*a. Public Hearing to consider approval of a revised **Site and Design Review** to build a new public library to be located at 162 NW 2nd Ave in the C-1 Downtown Commercial/Core Commercial subarea of the Downtown Overlay Zone (**DR 13-01**).*

SITE AND DESIGN REVIEW STAFF REPORT

FILE #: DR 13-01/VAR 13-01

APPLICANT: Eric Wilcox, FFA Architecture & Planning Inc.

Figure 20: Bike Rack Placement

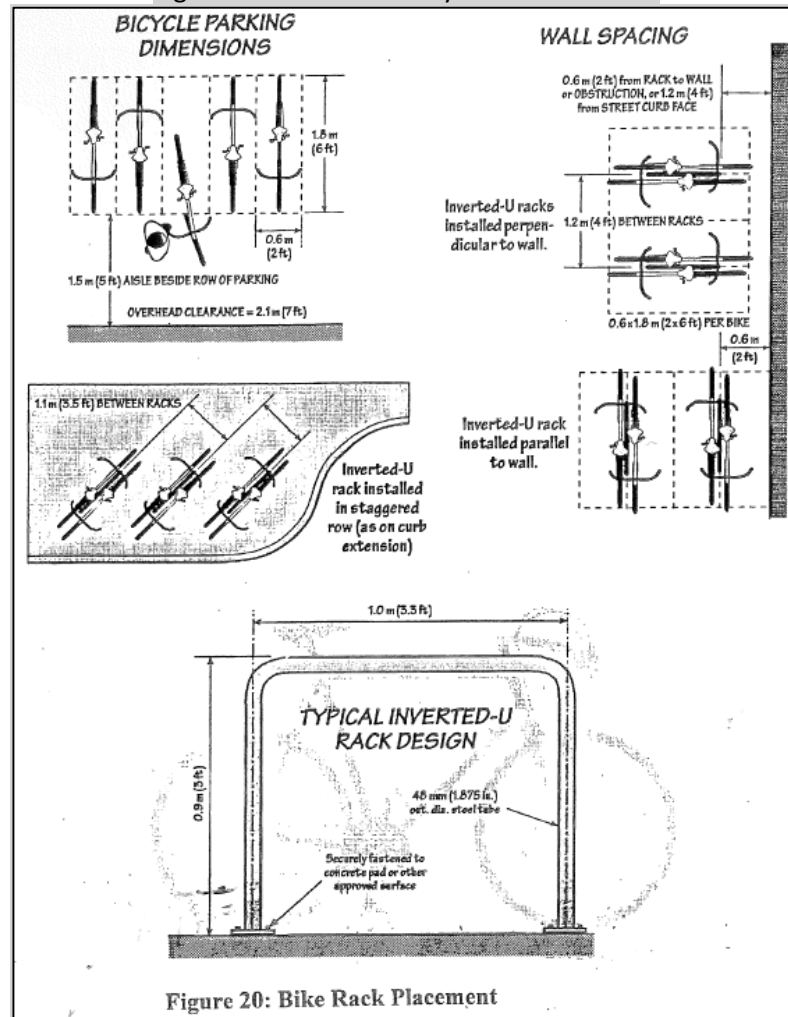
Findings: Per above, there shall be a minimum on 2 feet between the rack and a wall or other obstacle and the racks shall follow the guidelines of the Figure 20 from the Downtown Plan above. **This is a condition of approval.**

5. Per 16.10.100, there shall be a minimum on 2 feet between bicycle racks and a wall or other obstacle and the racks shall follow the guidelines of the Figure 20 from the Canby Downtown Plan.

EXTERIOR ELEVATIONS

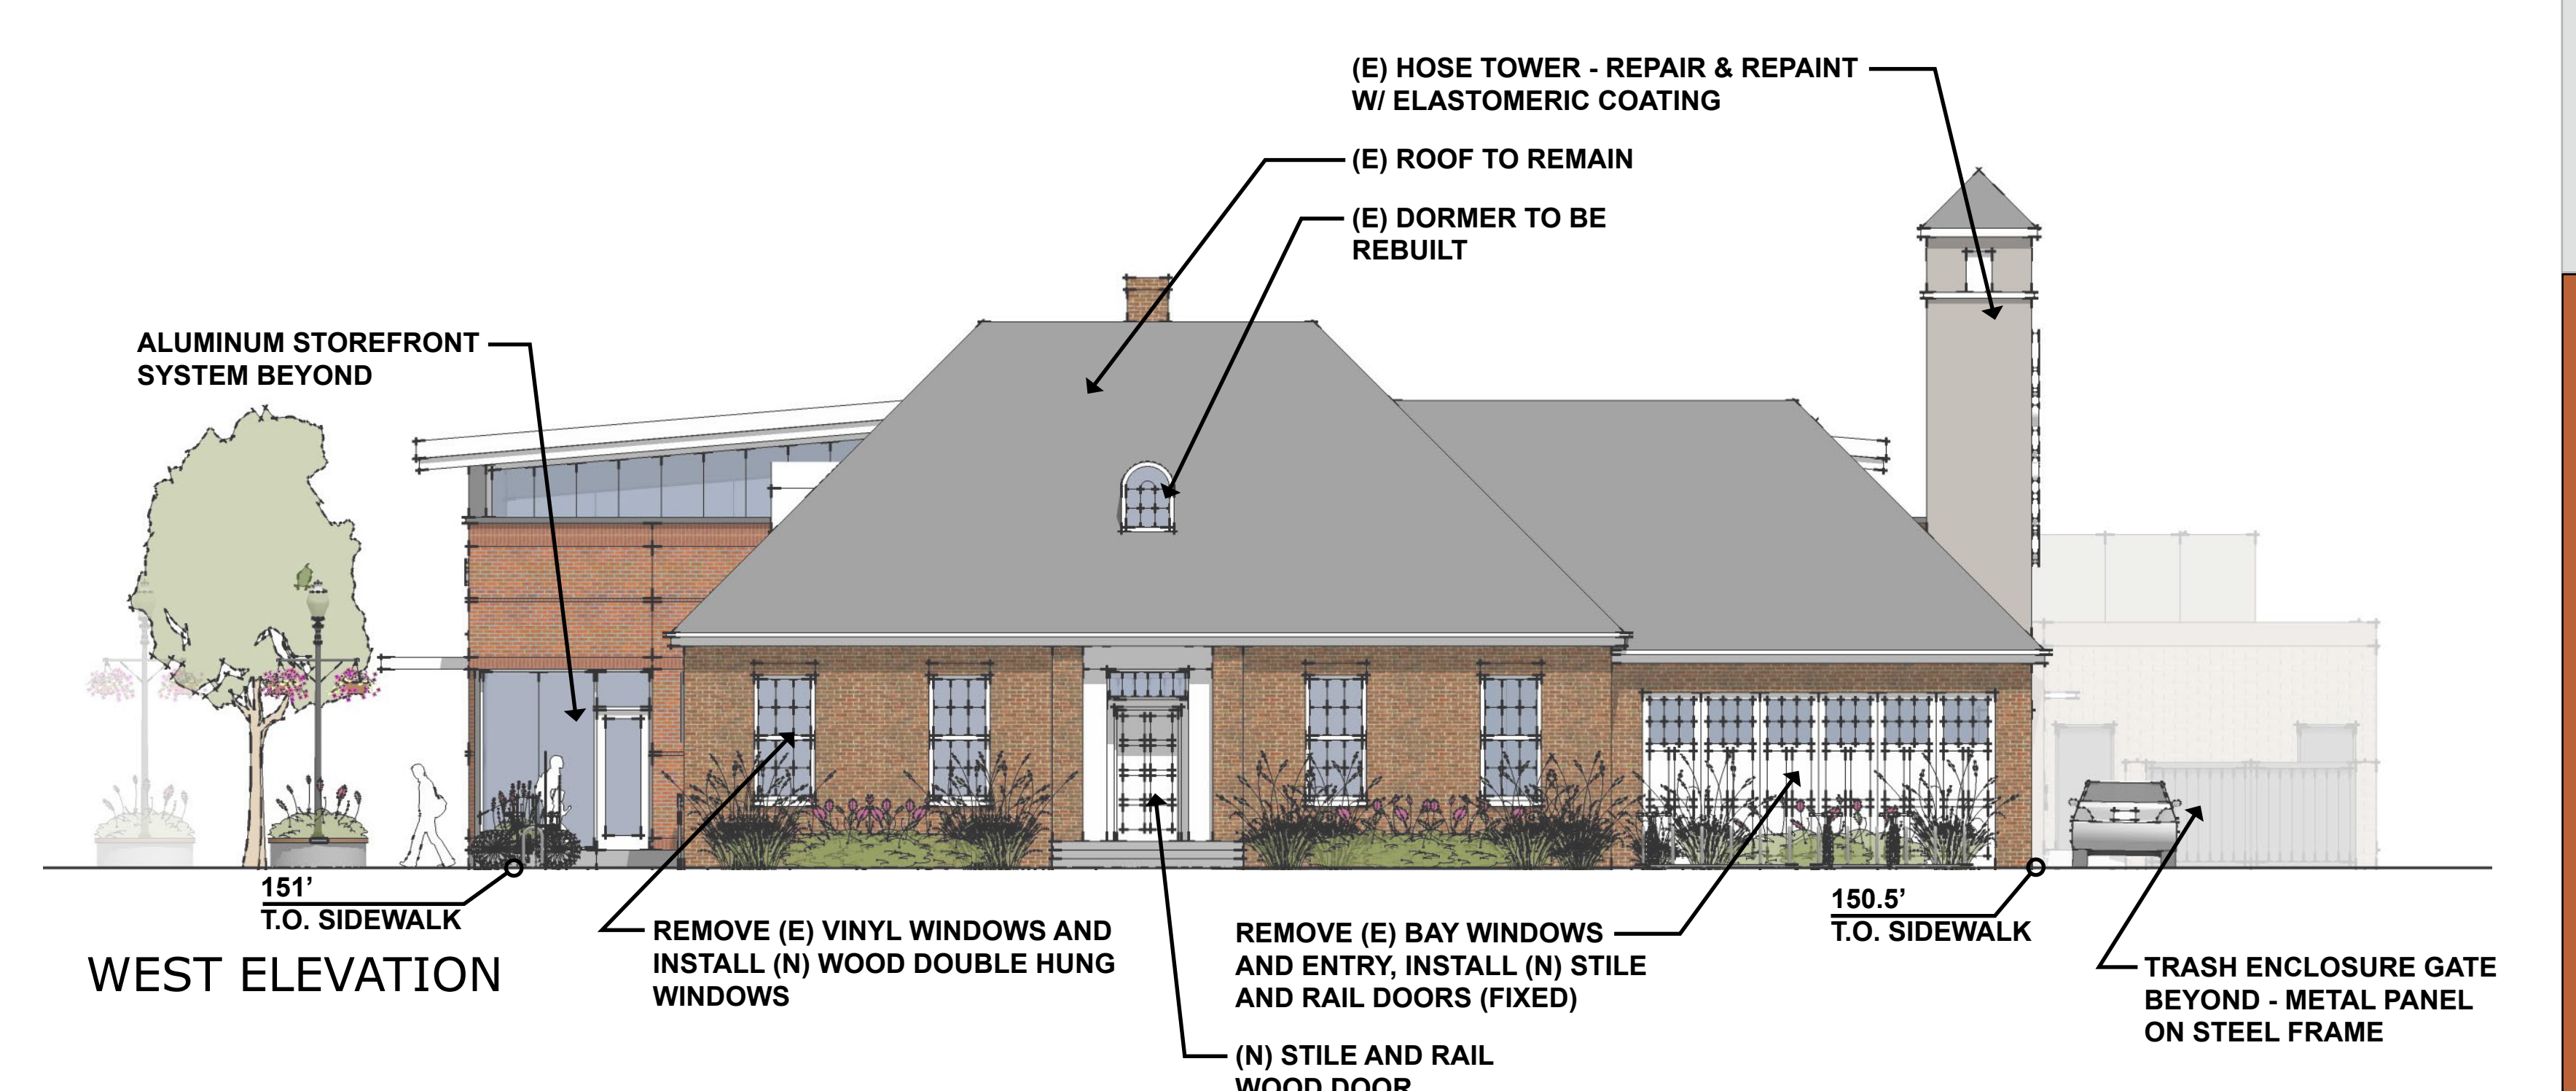
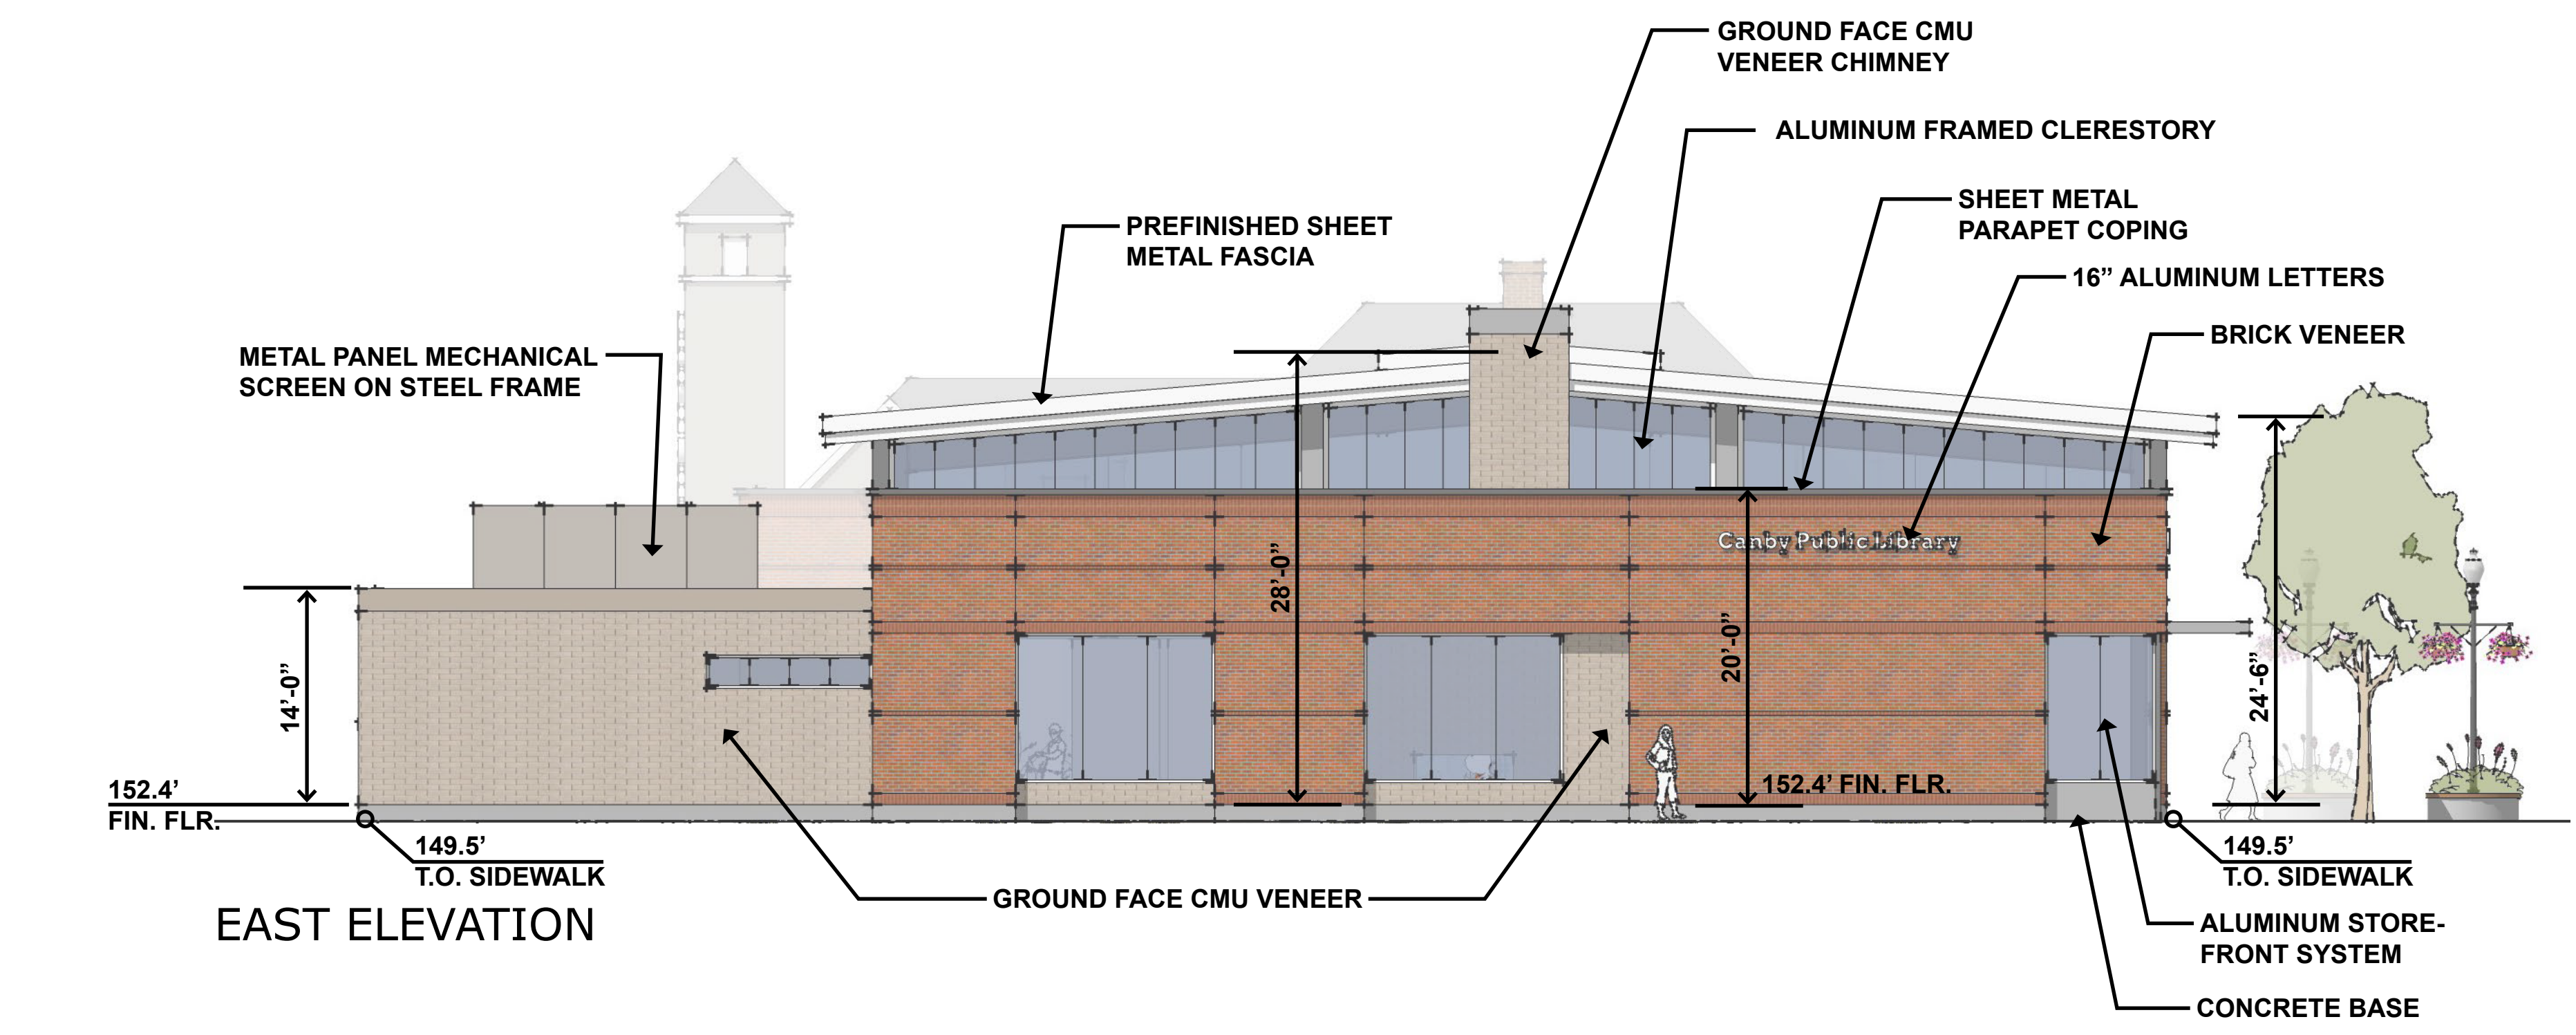
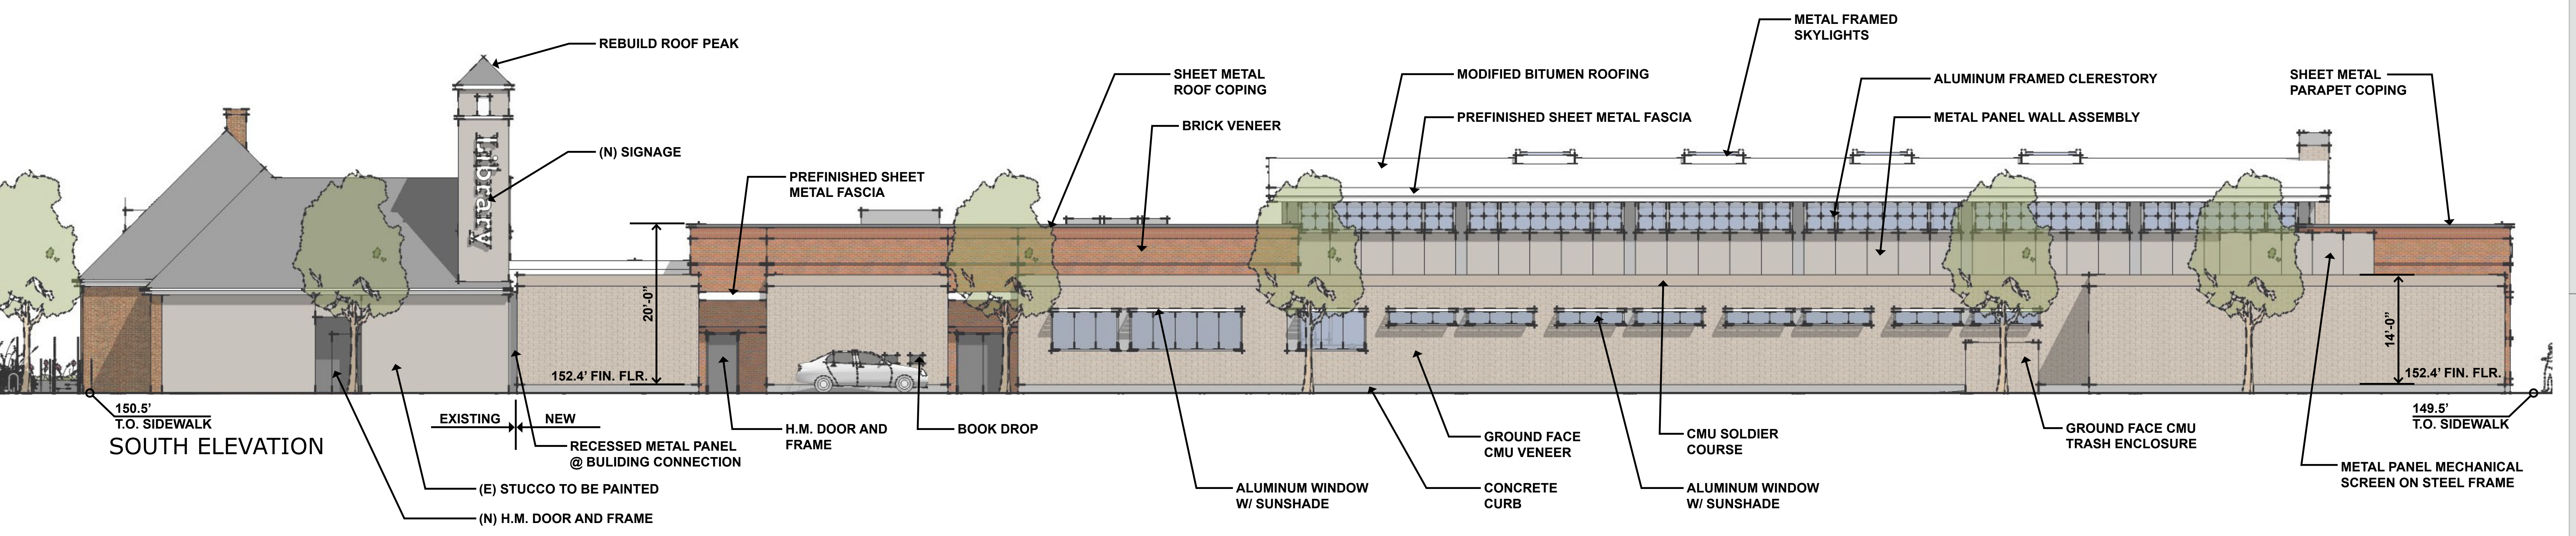
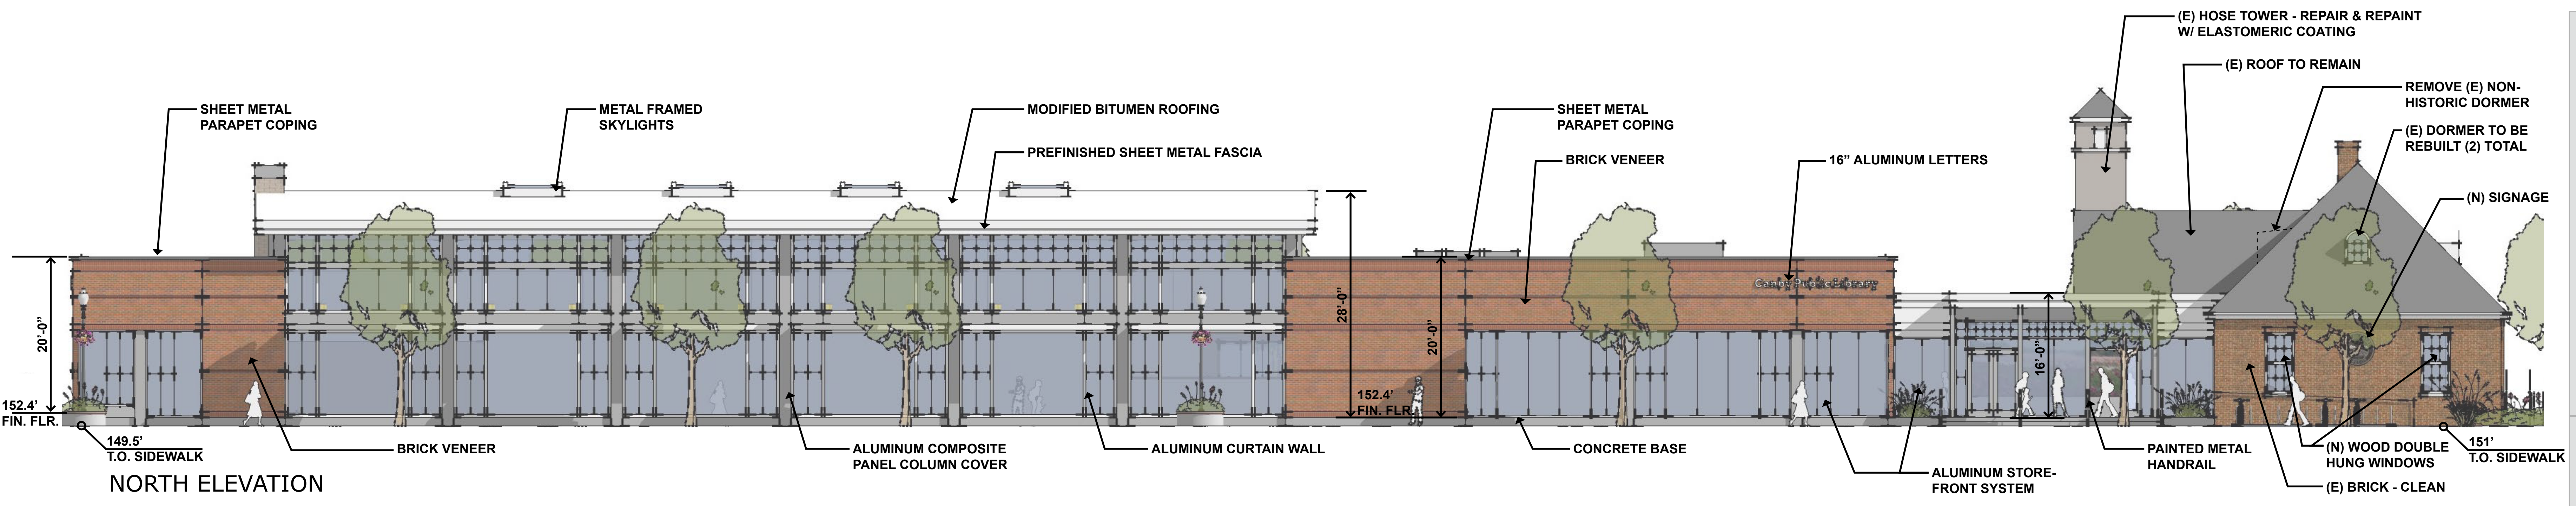
Findings: The window coverage along Ivy, the secondary street facing facade, does not meet this standard. The applicant’s response to this criteria is as follows:
 “The length and area is less the prescriptive amount. However the glass is located the corner of the building at 2nd and Ivy and at the fireplace hearth area. A third section of glazing is located in the adult reading area and provides transparency from the exterior into the reading area, while creating a pattern of solids and transparent elements. The southern 20’ of exterior wall is

part of the mechanical space within the building and not an area where windows are normally installed. If this 20' is subtracted from the wall length then length of glass is 50% of the wall and about 45% of the area. We believe that this layout meets the intent of this standard.” Per 16.49.040(C) and 16.49.035(A)(2), the Planning Commission has the discretion to approve alternative designs that meet the intent of 16.41. Therefore, if the Planning Commission approves this interpretation, then the above standard is met.

Findings: The above standard is not fully achieved along the Ivy Street frontage, the south elevation, and along portions of the 2nd Avenue frontage. Per 16.49.040(C) and 16.49.035(A)(2), the Planning Commission has the discretion to approve alternative designs that meet the intent of 16.41. Therefore, if the Planning Commission approves the facade designs, then the above standard is met.

Findings: Because the proposed building does not fully achieve the prescribed number of architectural bays per (1)(a) above, the above standard is not fully achieved. The applicant does propose several columns, beltcourses, awnings, and bulkheads. Per 16.49.040(C) and 16.49.035(A)(2), the Planning Commission has the discretion to approve alternative designs that meet the intent of 16.41. Therefore, if the Planning Commission approves the proposed designs, then the above standard is met.
